Job No. 2090-004-022

**RE: Pinnacle at Liberty Bay PRD & Preliminary Subdivision - Technical Review No. 1
Request for Revisions - P-06-20-25-03 - Response Letter**

JOB NO.:	2090-004-022
DWG. NAME:	EN-30
DESIGNED BY:	
DRAWN BY:	
CHECKED BY:	
DATE:	11/26/2025
DATE OF PRINT:

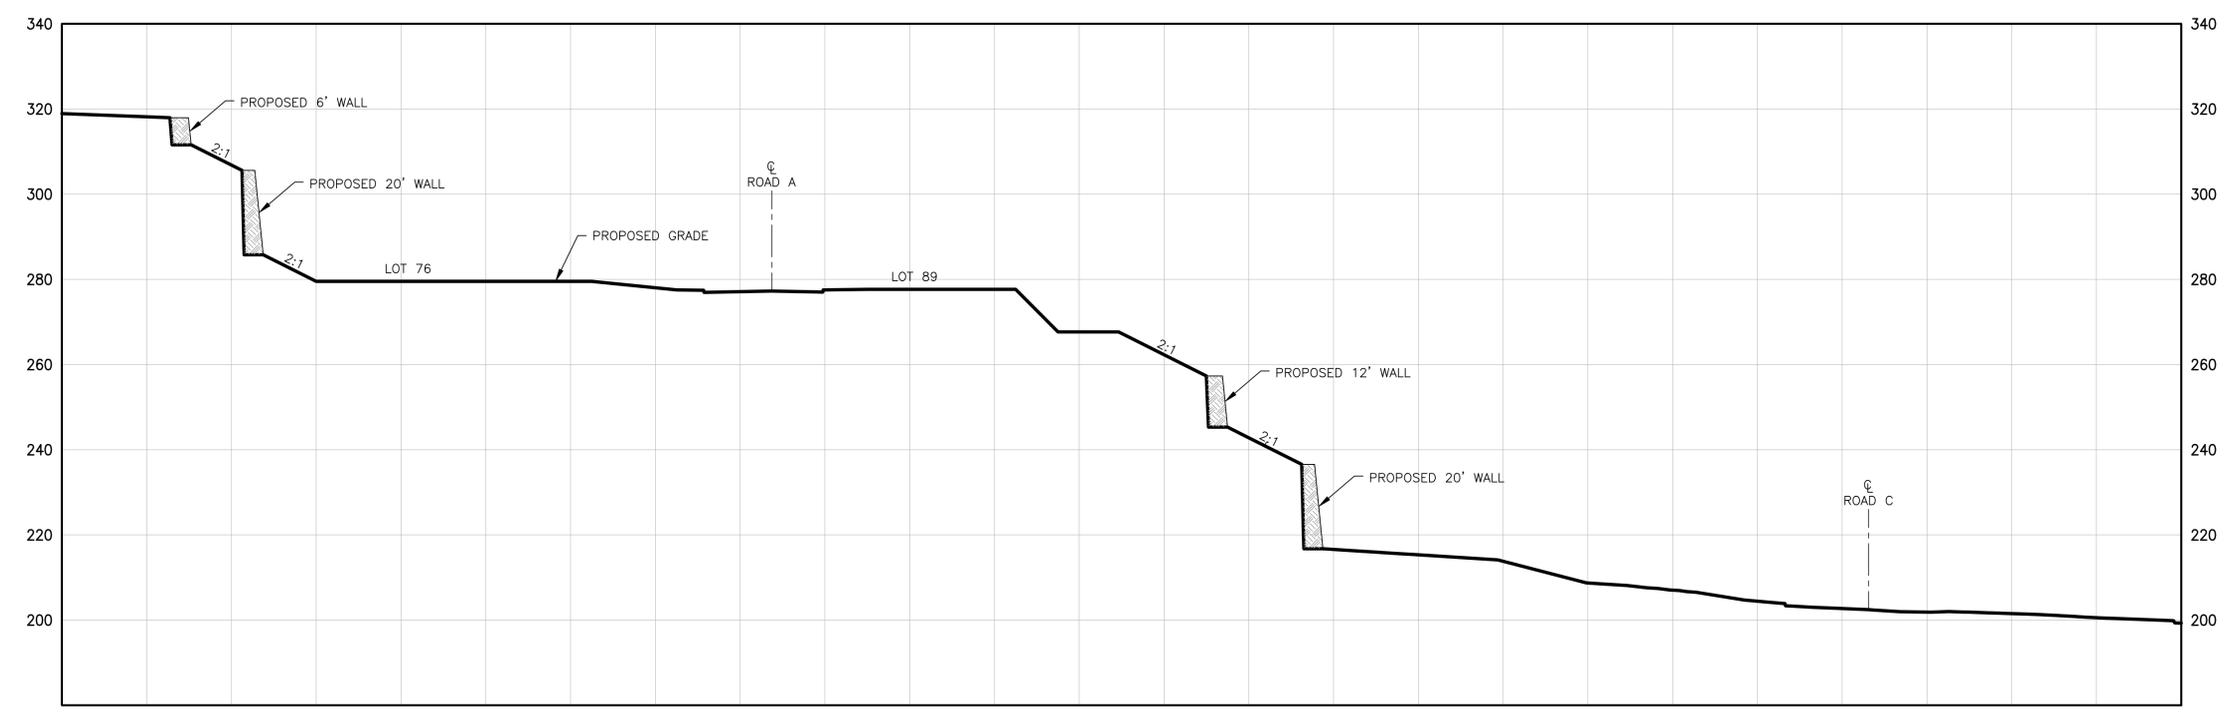
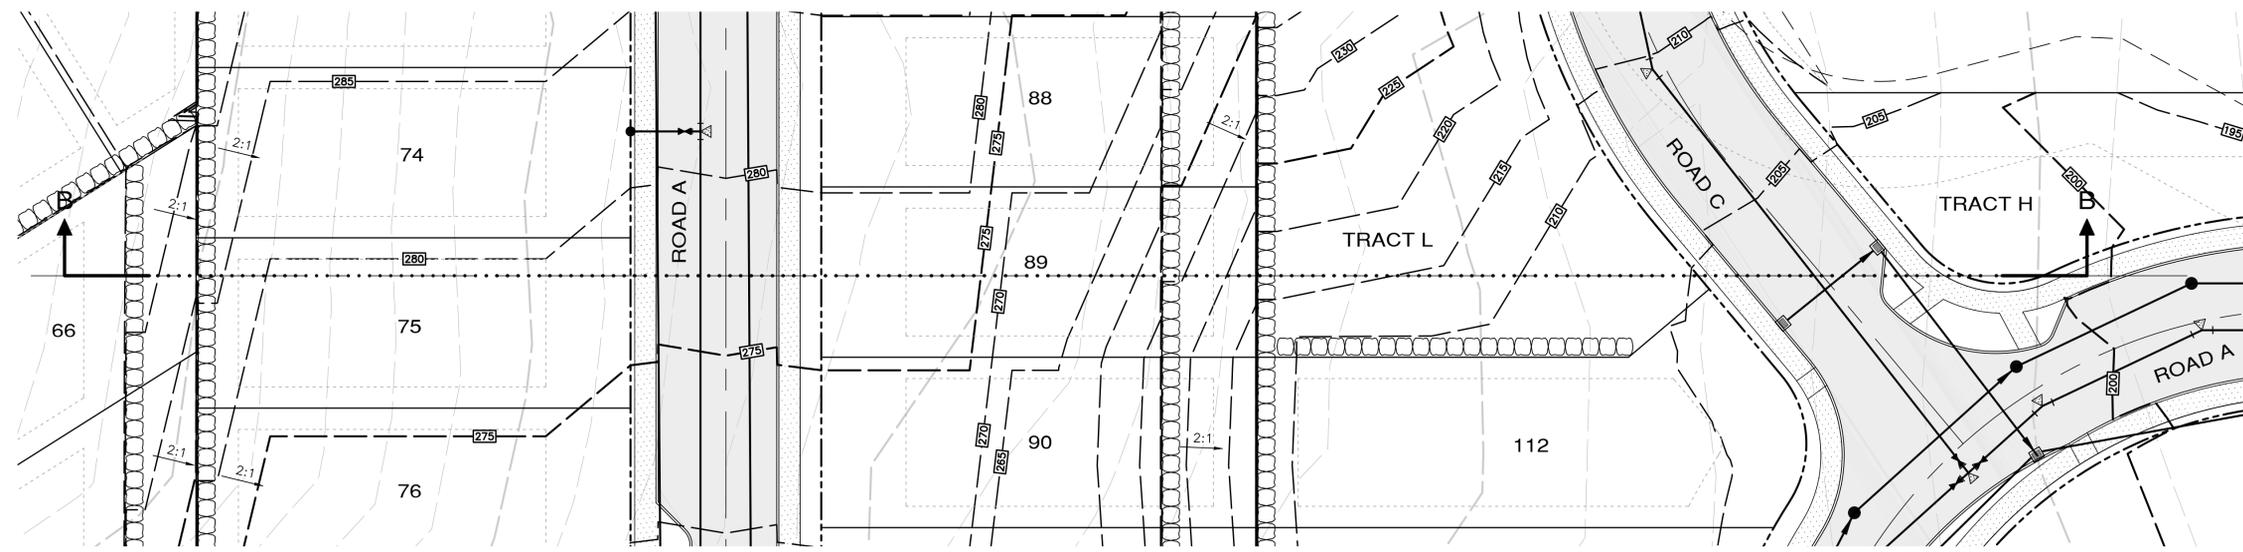
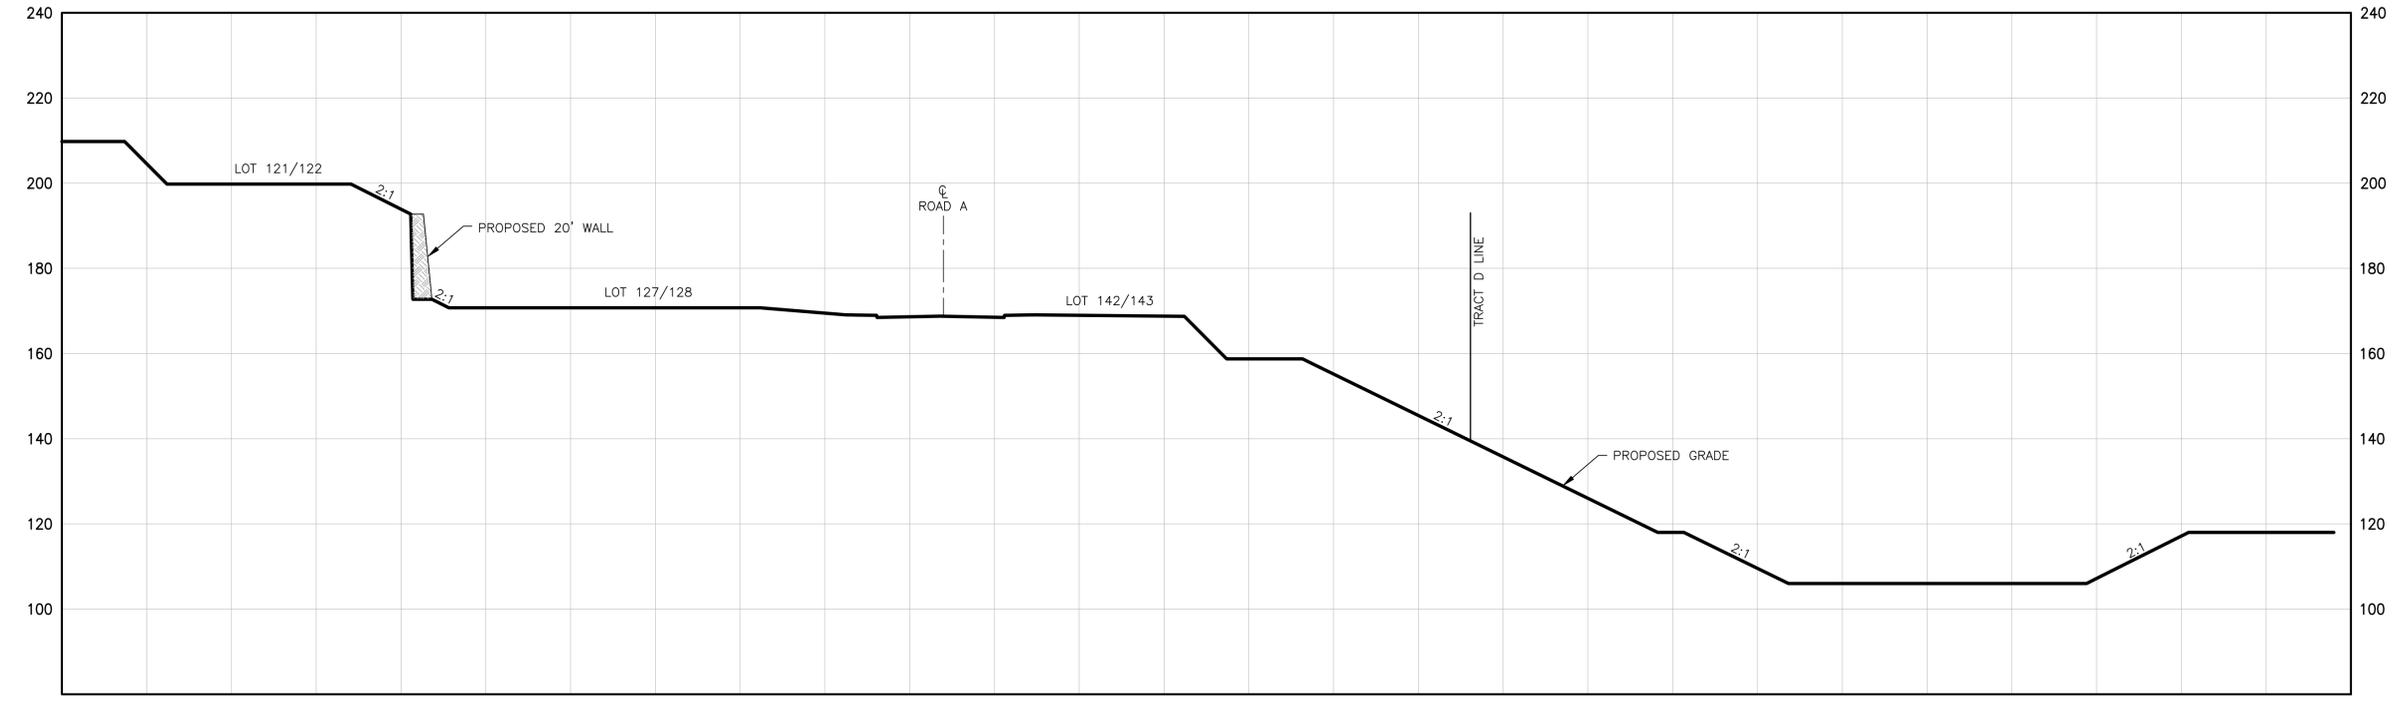
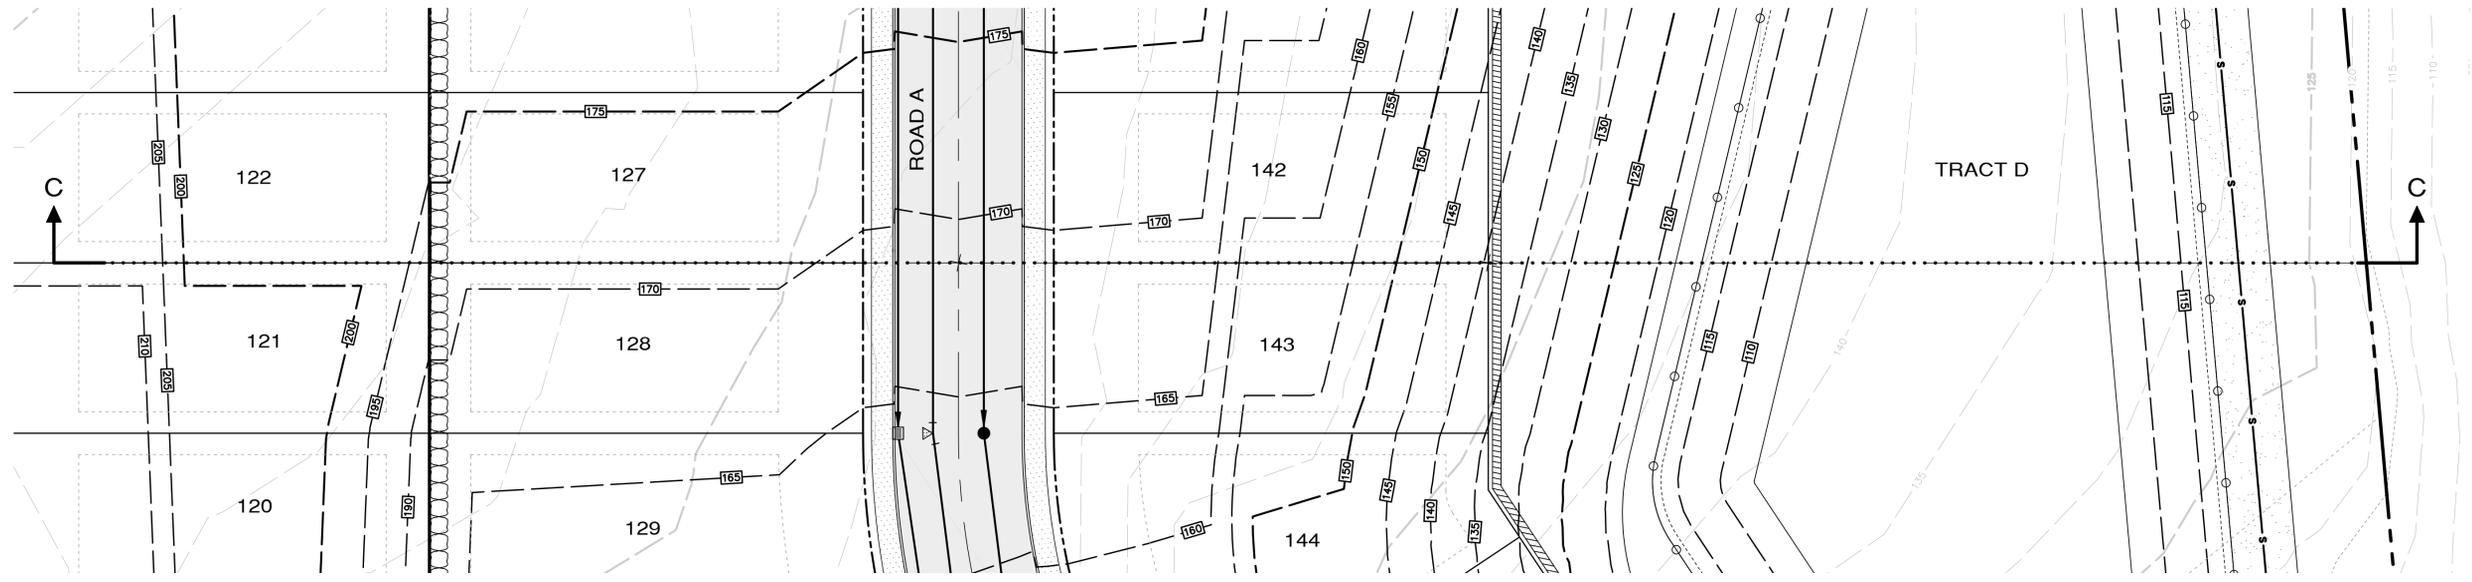
7. *Provide confirmation that the proposed building pads and access for lots 5-11, 75-76, and 127-135 are viable given the existing topography and proposed grading. Include additional details or cross-sections as needed to demonstrate that site*

constraints—such as slope, retaining walls, and driveway grades—can be reasonably accommodated within the proposed lot layout.

See Attachment 1 for cross sections further illustrating the viability of the noted lots.
